UNITED STATES PATENT AND TRADEMARK OFFICE

APPLICATION NO.	FILING DATE	FIRST NAMED INVENTOR	ATTORNEY DOCKET NO.	CONFIRMATION NO.
10/661,342	09/12/2003	Robert Paul Dressler	16466-US	8045

Office Action Summary

FIG. 4

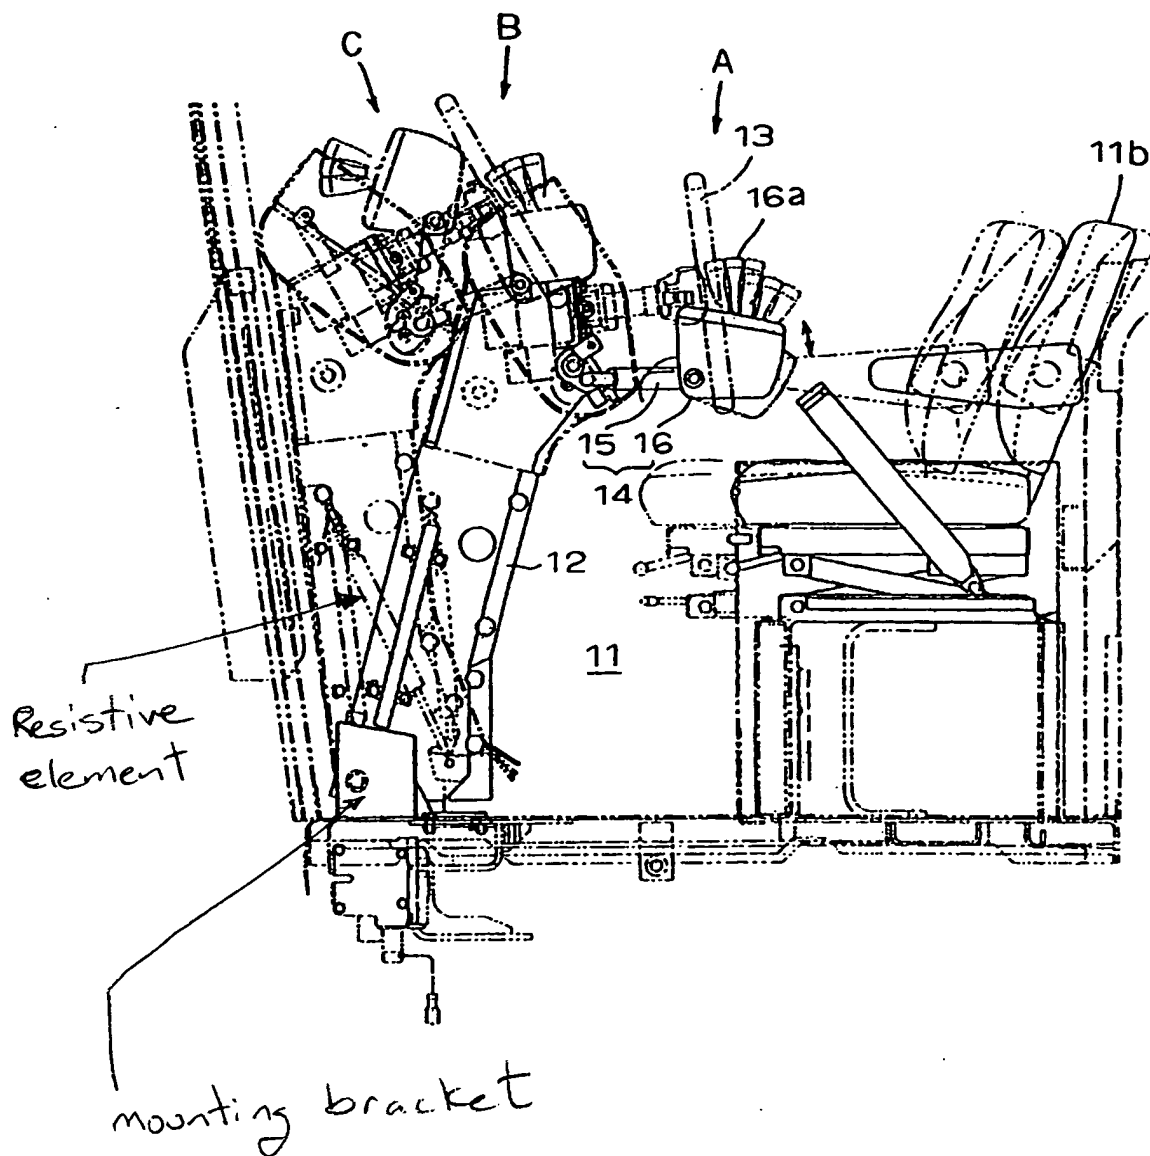
Nishimaki discloses a latchless controller positioning system including a mounting bracket (not numbered but shown in figure 4 (see also attached modified fig. 4), a control tower 12, a controller assembly 14, a resistive element not numbered but shown as a strut in broken lines in figure 4 (see also attached modified fig. 4) mounted to the controller tower and mounting bracket to provide a toggle effect as shown in figure 4.

Nishimaki discloses a controller positioning system for a work vehicle as described previously, but lacks specifying that the shown strut is a gas filled strut.

Volpel shows that a gas-filled strut 1 (see fig. 5 and column 2) is an equivalent structure known in the art. Therefore, because these two strut means were art-recognized equivalents at the time the invention was made, one of ordinary skill in the

art would have found it obvious to substitute the gas filled strut of Volpel for the unspecified strut of Nishimaki.
